Answers to the interactive comments from Dr. L.A. Melsen (lieke.melsen@wur.nl).

Answers to the interactive comments from the anonymous referee #2

AC: *The title is changed as: "ORCHIDEE-ROUTING: Revising the river routing scheme to use a high resolution hydrological database". The Abstract and Introduction are reworded to precisely describe the study in this paper (see p.1 l2-7, p.2 l3-24, p.3 l14-19).*

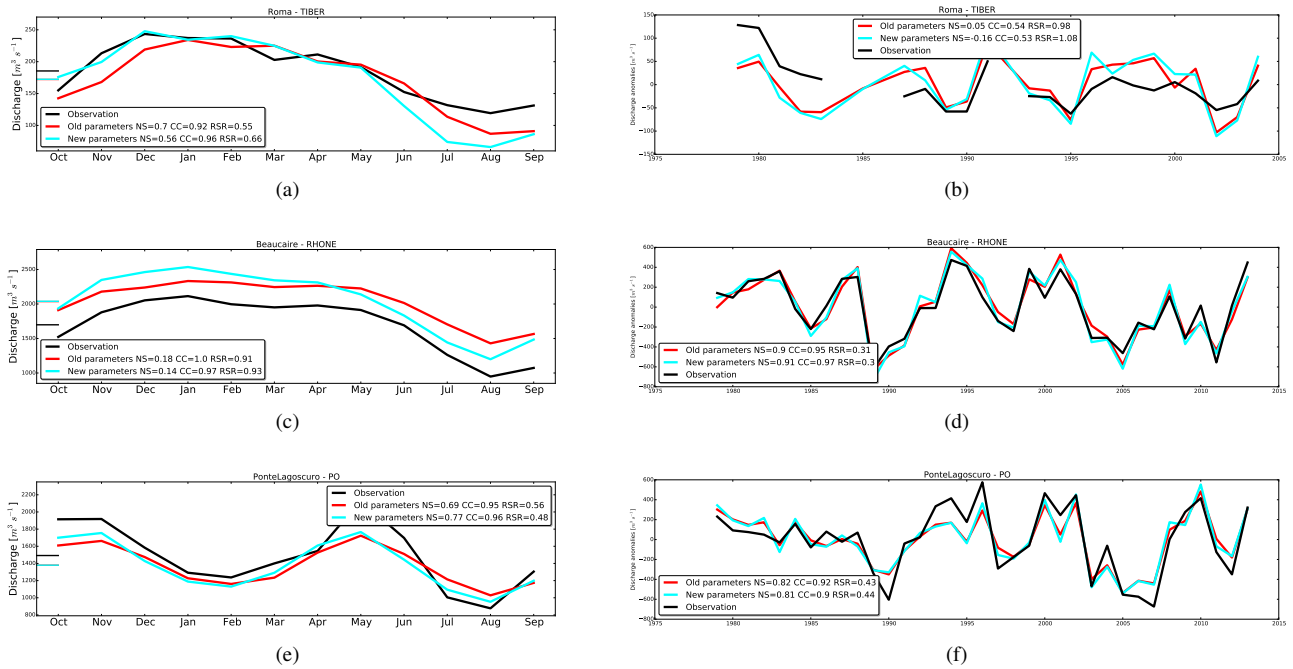
RC: In Section 3.4, three reservoir parameters have been calibrated based on the Rhone data, and subsequently these parameters have simply been applied to all basins. That does make me wonder how sensitive the routing model is to these parameters, and how different the parameters are when calibrated on another basin. I think this is too important to simply step over like is done now.

AR: Authors agree with the reviewer that the calibration of three reservoir parameters is an important issue, especially when the RRS is applied for one specific catchment. Indeed, two wonders of the reviewer are too complex and difficult to satisfactorily solved within the scope of this article. Figure 1 shows a simple experiment to answer the question of how sensitive the new RRS is to these parameters. The new RRS is run with new reservoir parameters (i.e. 0.01, 0.5 and 7.0 day/km) and old parameters (i.e. 0.24, 3, and 25 day/km) with maximum one HTU per a ORCHIDEE grid box. As can

5 be seen both in the mean annual cycle and monthly discharge anomaly series, there are not significant differences when applying two parameter sets. In this case, although the values of two parameter sets are quite different, we can see that the sensitivity to the reservoir parameters are not remarkable. One reason can be expected is that the slope index which calculated from the HydroSHEDS play an important role in the control of river flow. However, there is a caveat that only one HTU is constructed in each ORCHIDEE grid box. This threshold leads to a small number of HTUs in simulated river network for the Rhone (47 HTUs), the Po (48 HTUs) and the Tiber river (6 HTUs). Since being a unit-to-unit routing scheme, the new RRS is also sensitive to the number of HTUs. In fact, the impact of the number of HTUs and routing time step on the simulated river discharge cannot be separated from the effect of reservoir parameters.

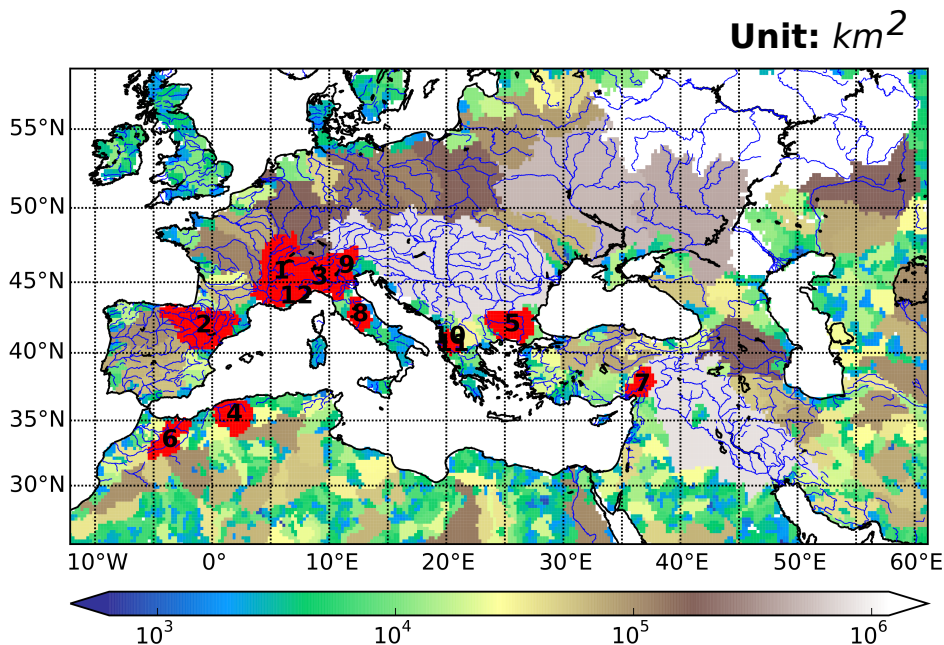
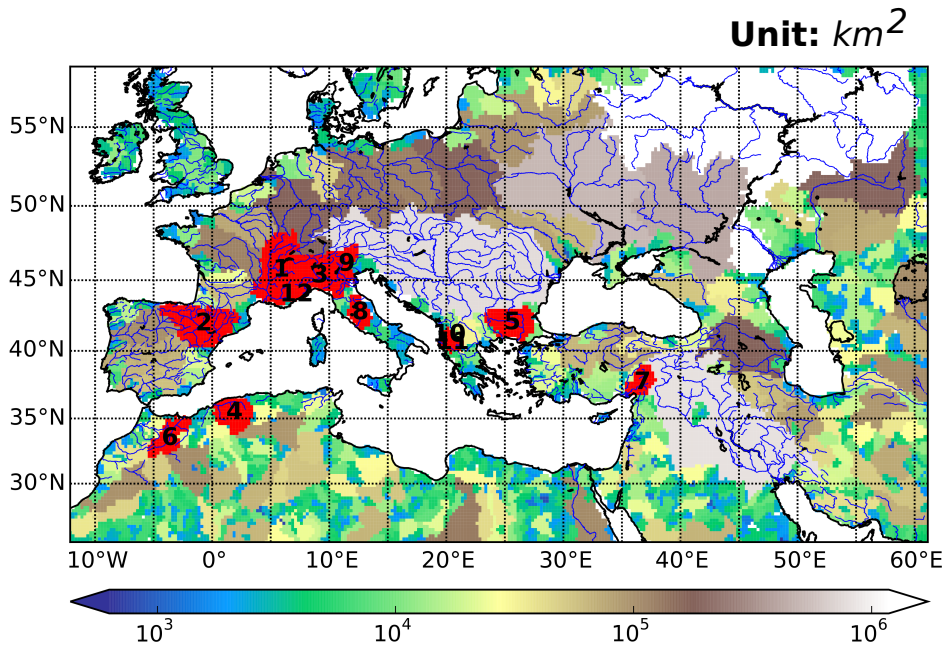
3. The color of the Figure 1.

RC: Figure 1: the red colour appears in the legend, but is also used to indicate the regions of this study. It is unclear if the red colour then still refers to the legend colour too.

AR: The authors will use another color palette without red color for displaying the area of river catchments. The red color is still used to emphasize the 12 researched rivers.

AC: The color of the Figure 1 in the manuscript is modified as the Figure 4 below (also see p.5).

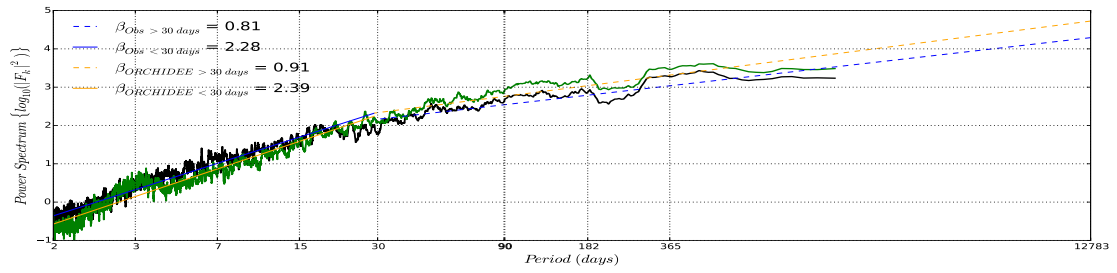
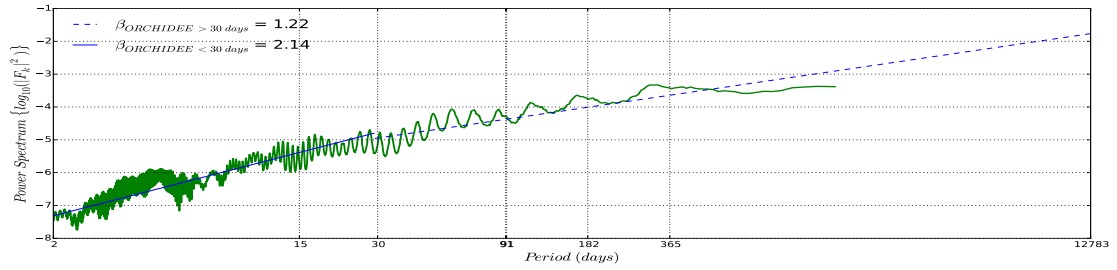
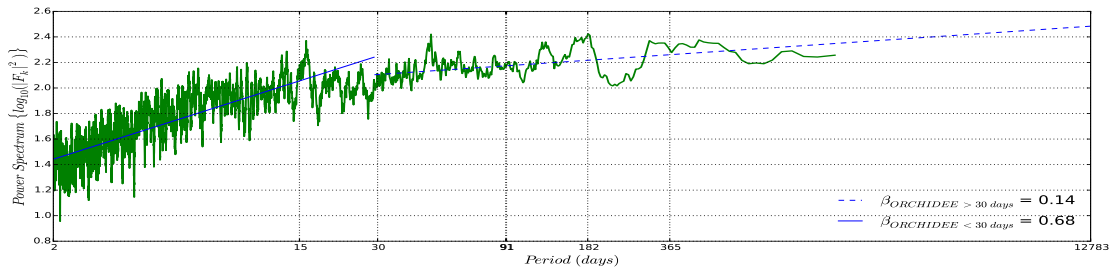
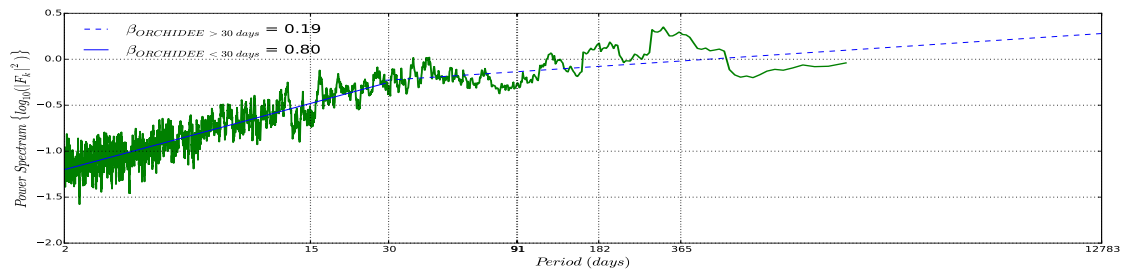
RC: p.14 l. 28 I am not familiar with the power spectrums discussed here. Perhaps some more information on this methodology can be provided, and what the implications of the results are.

15 **AR:** The authors will provide more arguments with references in order to give more information on the spectrum analysis. Spectral analysis is a robust method to reflect the space-time multi-scale variation of both rainfall and runoff processes over wide ranges of basin size (i.e. from five to two millions square kilometers, Pandey et al. (1998)). It also possibly suggests physical explanations for time scale dependant relationship. For example, a 3 to 6 years oscillation typical of El Niño Southern Oscillation variability is observed in monthly river discharges of four Atlantic large rivers (Labat et al., 2005). Moreover, the spectral approach facilitates the diagnosis and development of hydrological models

AC: More arguments about power spectrum analysis are provide in the paragraph starts after p.15 l.31:"It is a robust method to analyse the multi-scale temporal variations in the various variables contributing to the river discharge. As has been shown by Weedon et al. (2015), it facilitates the diagnosis and development of hydrological models. In the power-spectra trend lines for high frequencies (Variation faster than 30 days) and low frequencies (slower than 30 days) are also plotted".
